RE: Deficiency Letter for Letter of Interpretation - Line Verification
File No.: 1427-08-0004.1 (FWW 080001)

Applicant: New Jersey Foreign Trade Zone Venture, LLC; Rock-Morris, Inc.,
member
Block: 103; Lot: 2.04
Mount Olive Township, Morris County

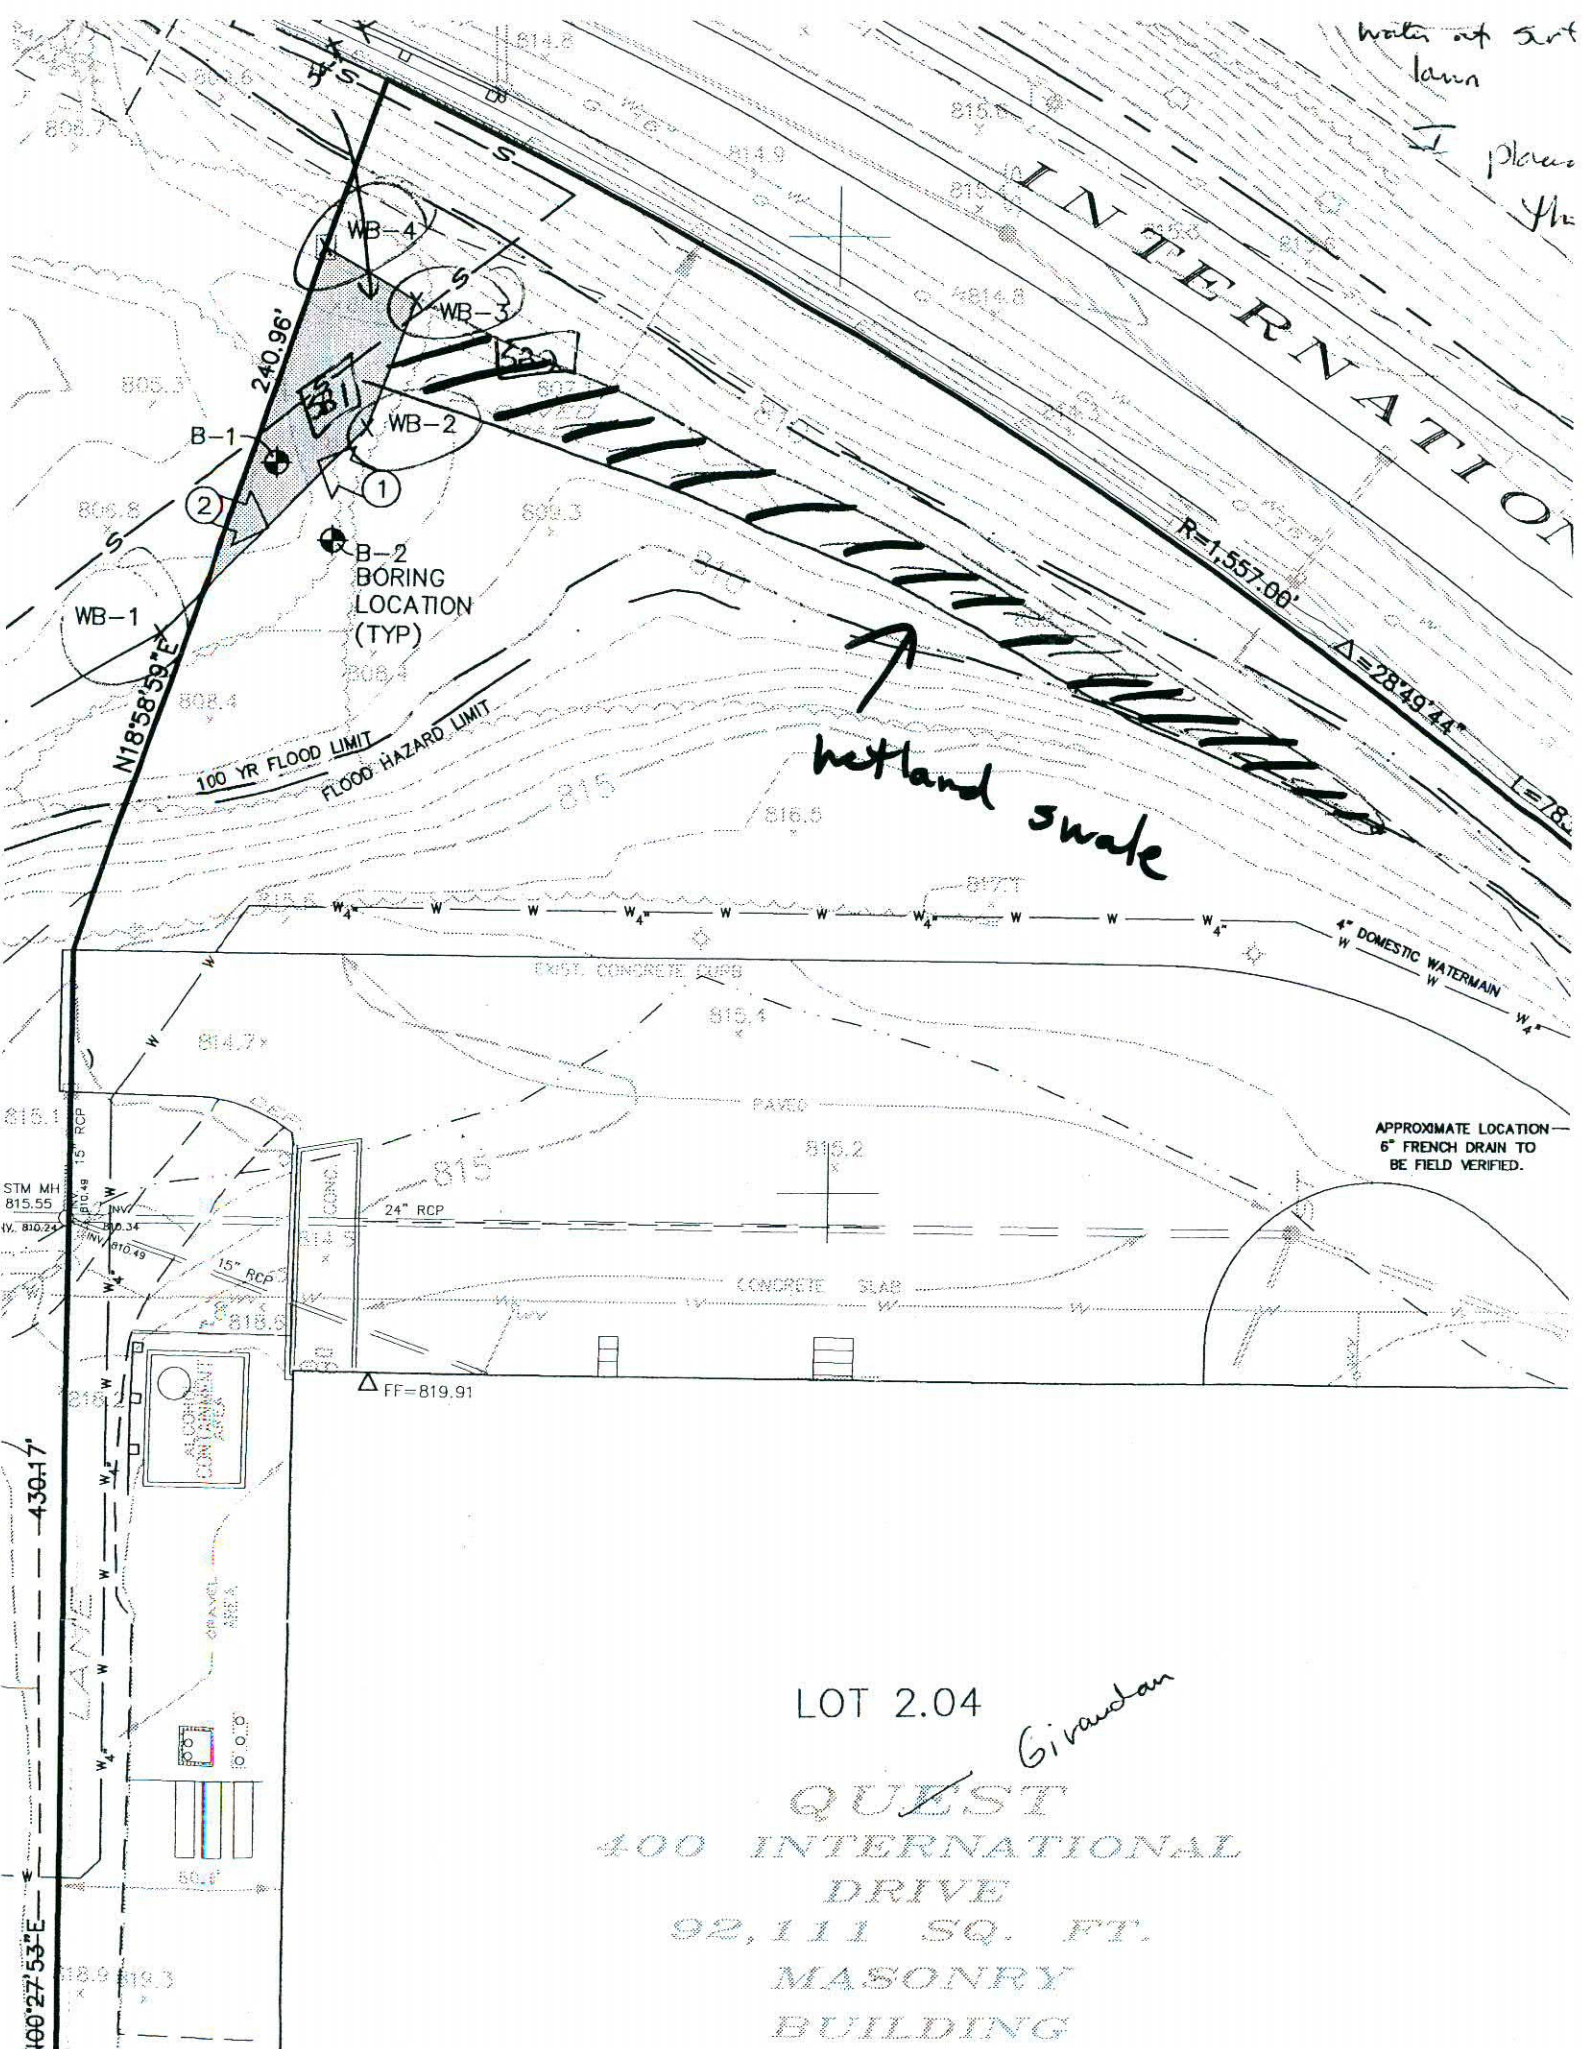
1. Additional wetlands are present on the property in the form of a swale which drains to the depicted wetlands, between points “WB-2” and WB-3”. I placed a flag at the top of the swale, where the wetlands begin. Attached is a general sketch of the additional wetlands for general information purposes only. This wetland swale needs to be flagged and surveyed for inclusion on a revised Wetland Map.

water at 50 ft
lawn
I place
the

wetland swale
